FINAL PLAT OF "BUU QUANG TEMPLE" AN ADDITION TO WICHITA, SEDGWICK COUNTY, KANSAS IN THE NE 1/4 OF SECTION 21, T28S, R1E OF THE 6TH P.M.

RE: S/D 99-44— One-Step Final Plat of BUU QUANG TEMPLE ADDITION

RE: S/D 99-44— One-Step Final Plat of BUU QUANG TEMPLE ADDITION

CASE NUMBER: S/D 99-44 - BUU QUANG TEMPLE ADDITION

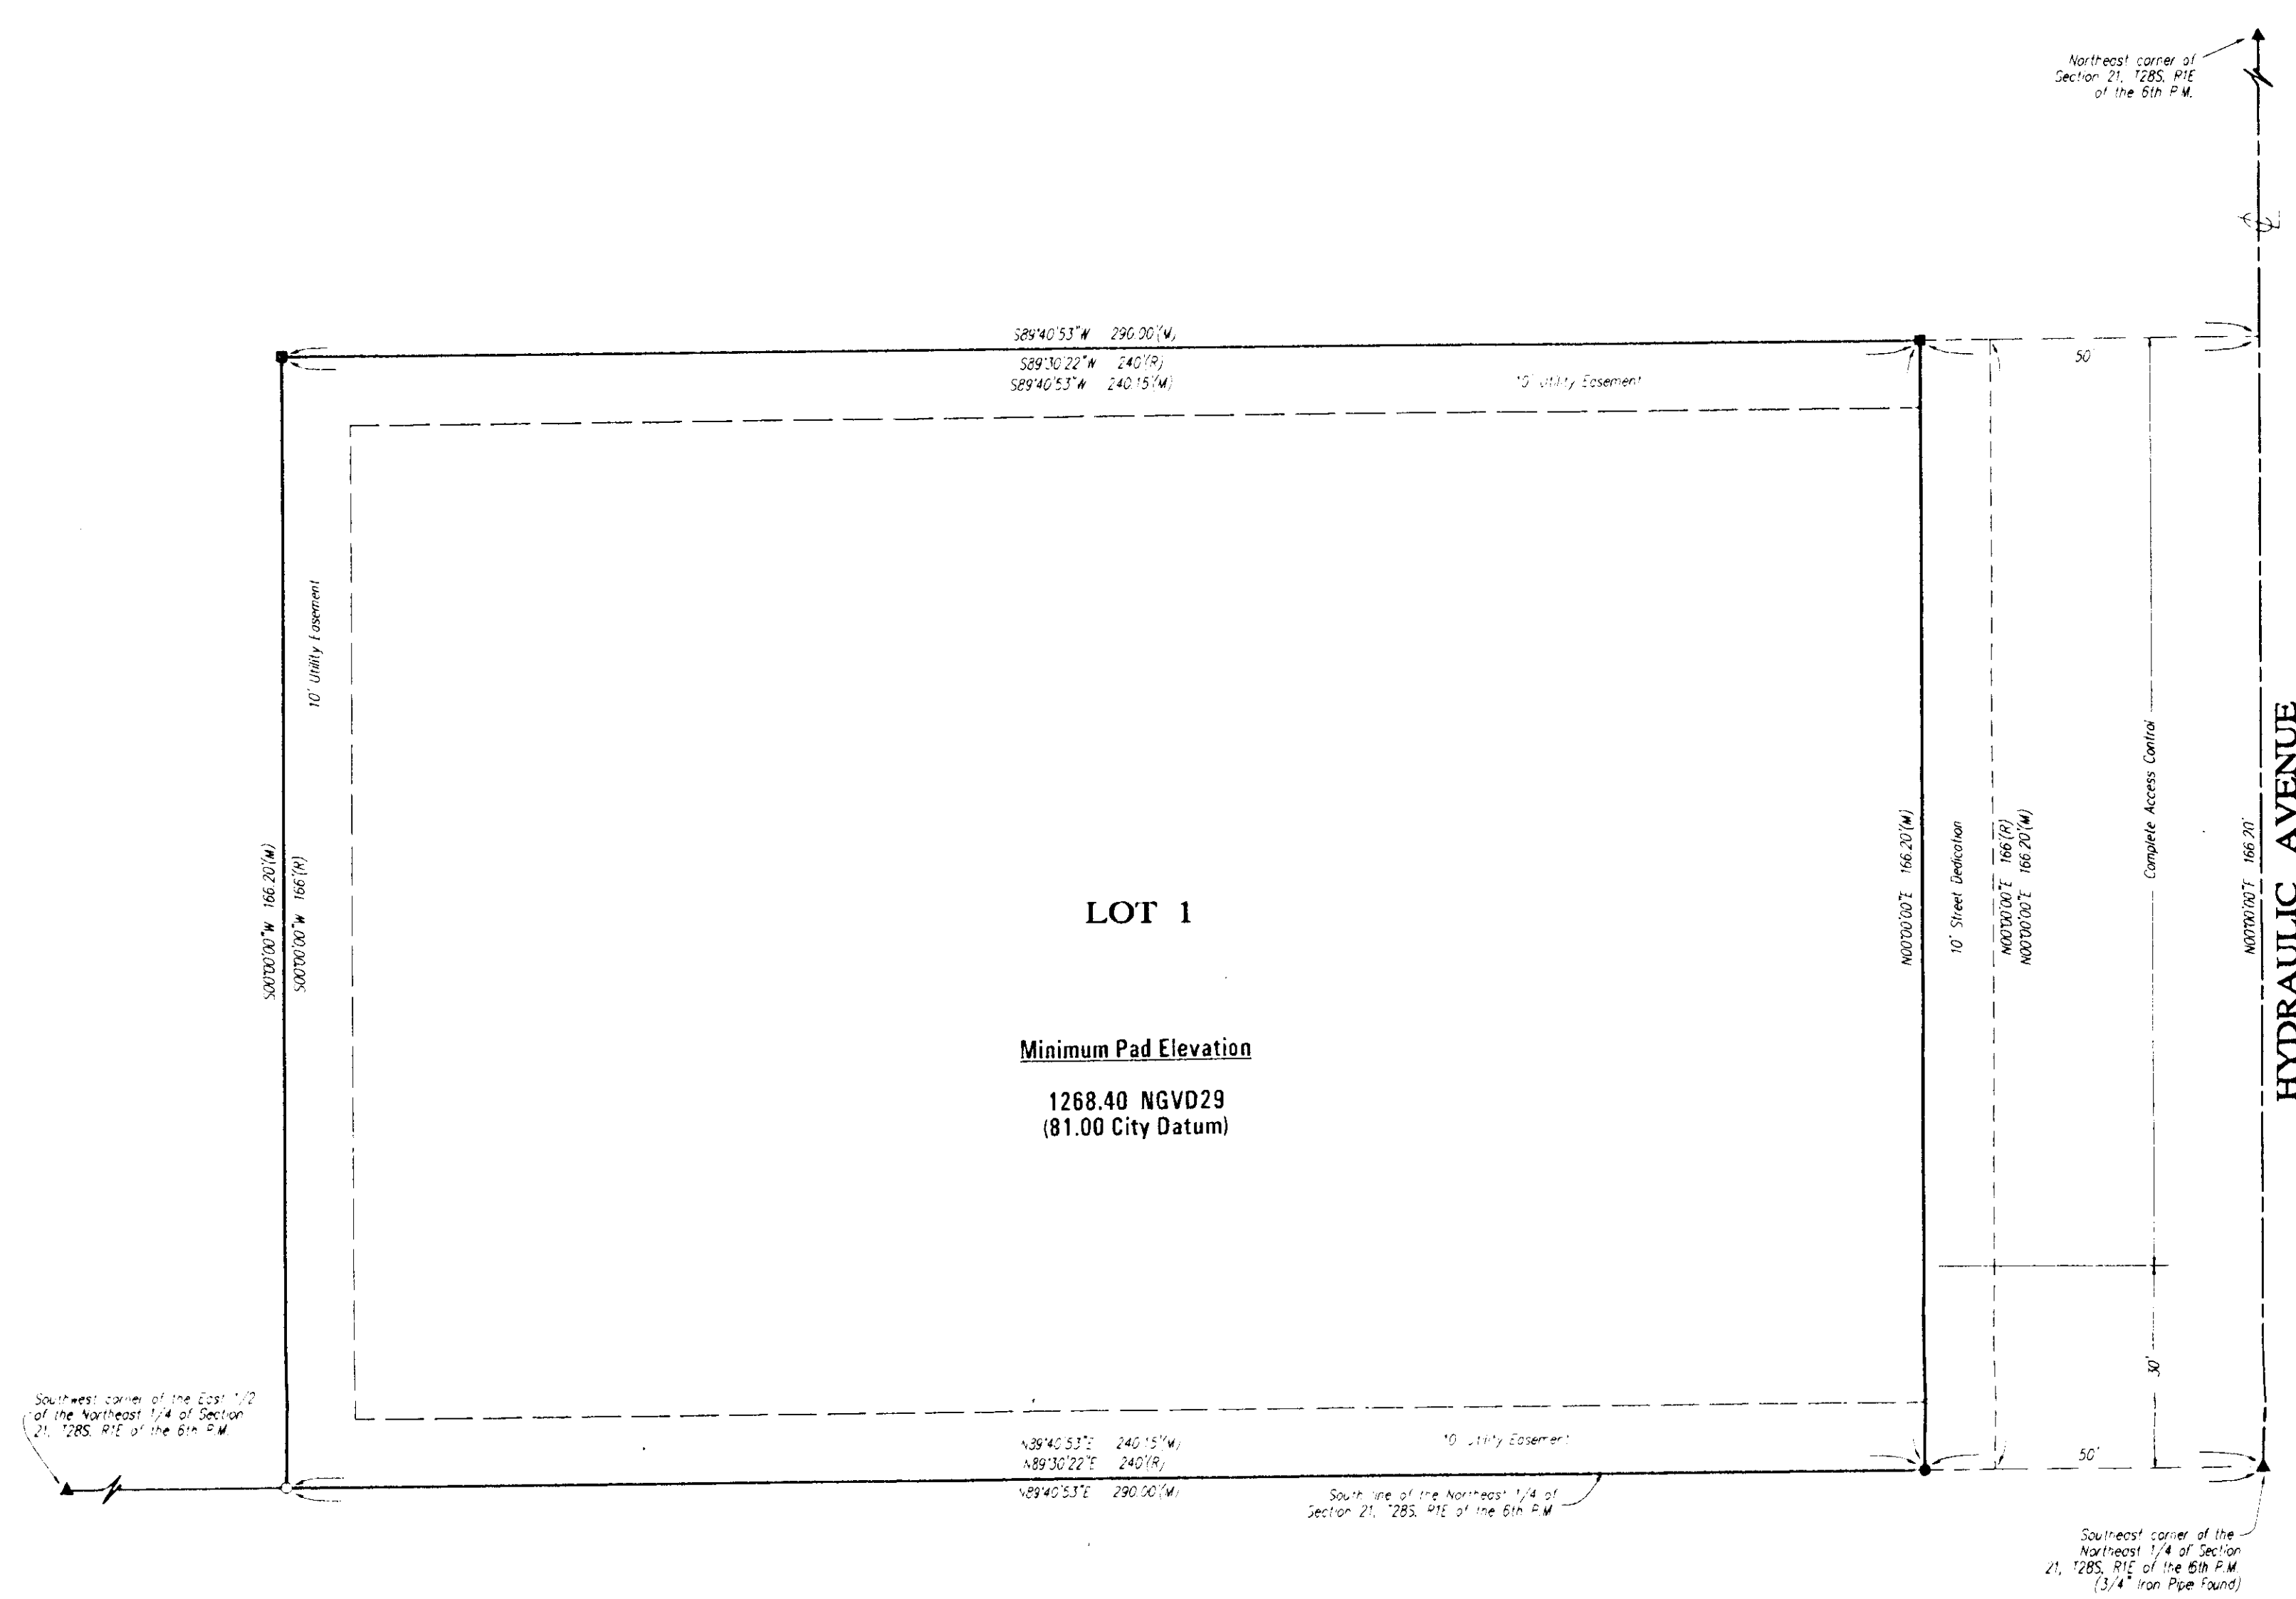
- C. ✓ **City Engineering** needs to comment on the status of the applicant's drainage plan. **The drainage plan is approved.**
- D. ✓ **Traffic Engineering** needs to comment on the access controls. The plat denotes an existing access opening along the south 30 feet of the lot's frontage to Hydraulic. **The access controls are acceptable.**
